Phoenix Park Mobility Report

Submission Fingal Cycling Campaign

Figure 3 Schematic Detailing Greater Dublin Area Cycle Network Routes in Phoenix Park

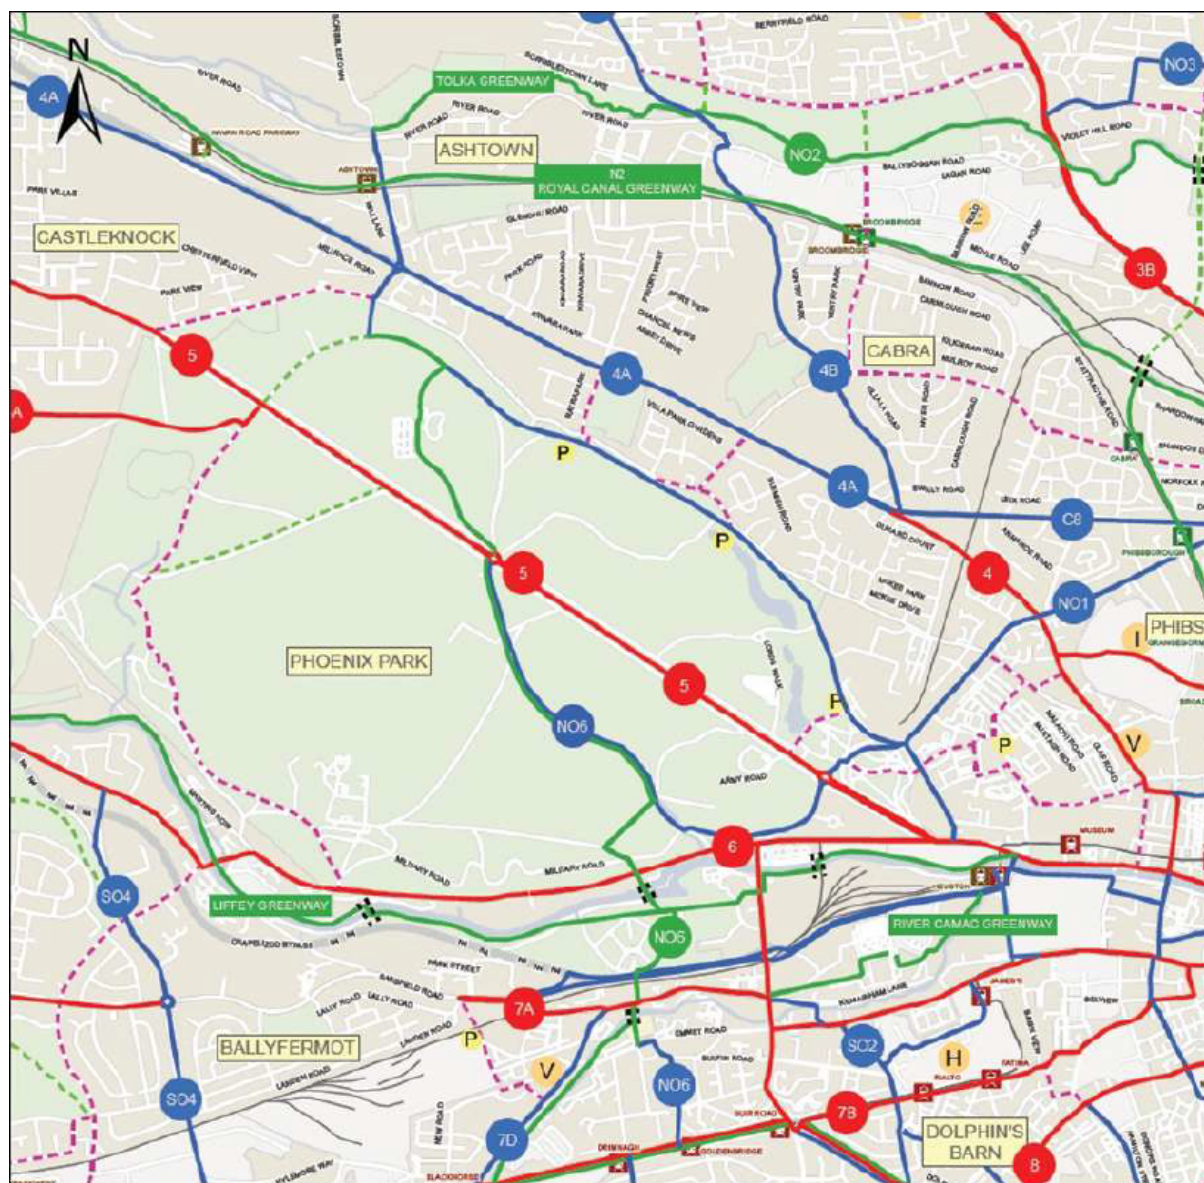
Despite this, the network fails to align with Route 5a (Figure 3) branch from Phoenix Park via White's Road and Carpenterstown to Blanchardstown from Coolmine. Route 5a will provide a vital connection for the thousands living in West Fingal with a vital cycling route into the city centre. This oversight should be addressed before implementation of the upgraded network. Additionally, facilitating the Route 5a will provide a safe cycling route to Farmleigh House which would fulfill the Steering Group Movement Principle to:

Figure 5 Graph Illustrating Significant Volumes of Traffic on Castleknock Rd (Oak Lawn)

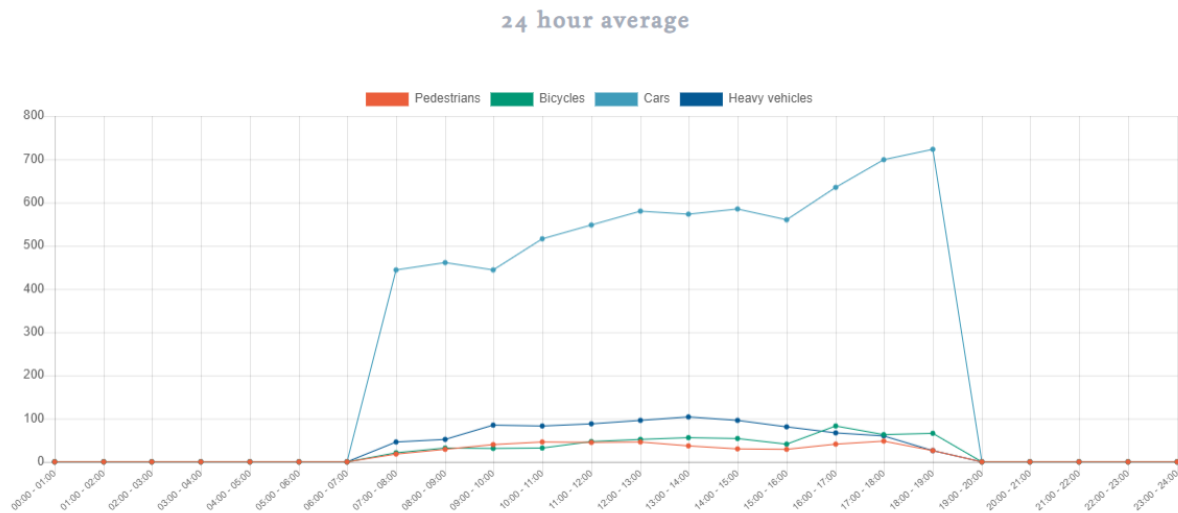
Castleknock Village has been choked with traffic for years. The Phoenix Park's inadvertent use as a strategic commuter route has contributed substantially to this congestion. Figure 5 represents the traffic travelling through on the Castleknock Rd during Covid-19 related lockdown restrictions. When restrictions lift, the traffic measured will soar.

Figure 7 Schematic Illustrating PM Peak (17:00-18:00) Traffic Phoenix Park Gate Screenline

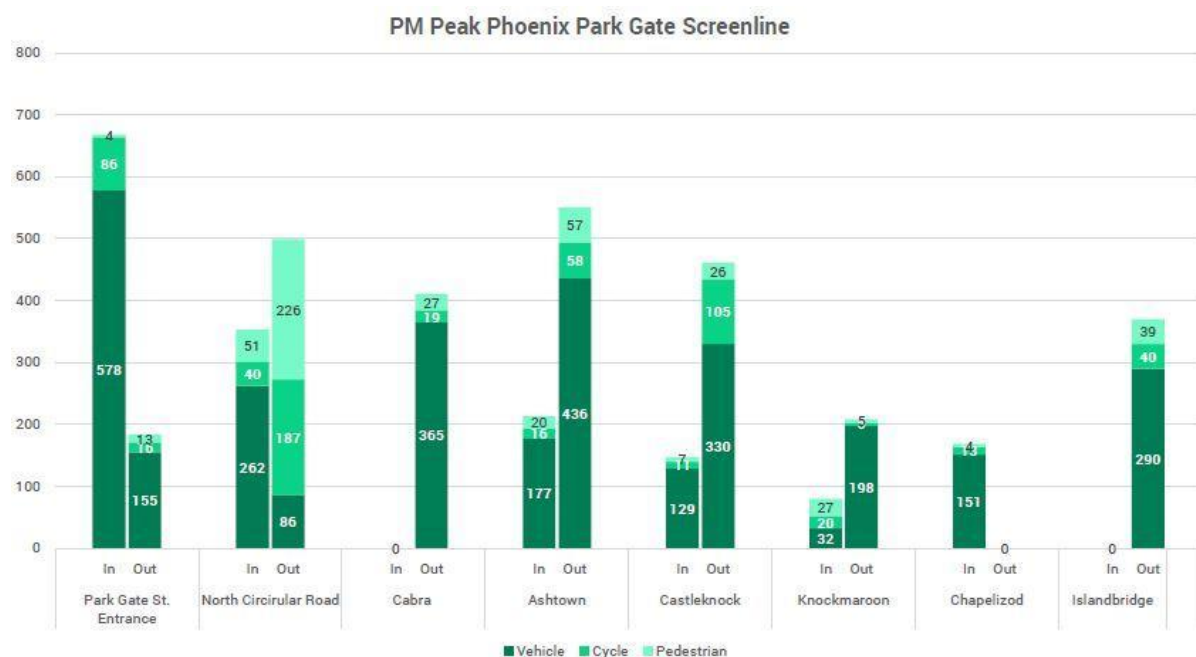
will have a high probability of increasing the traffic through Castleknock Gate. Commuters travelling north through the park, who have their exit prevented by Ashtown Gate being entry only, will continue their journey through Castleknock Gate instead. There could be up to a 135% increase in peak traffic exiting the Castleknock Gate (Figure 7).
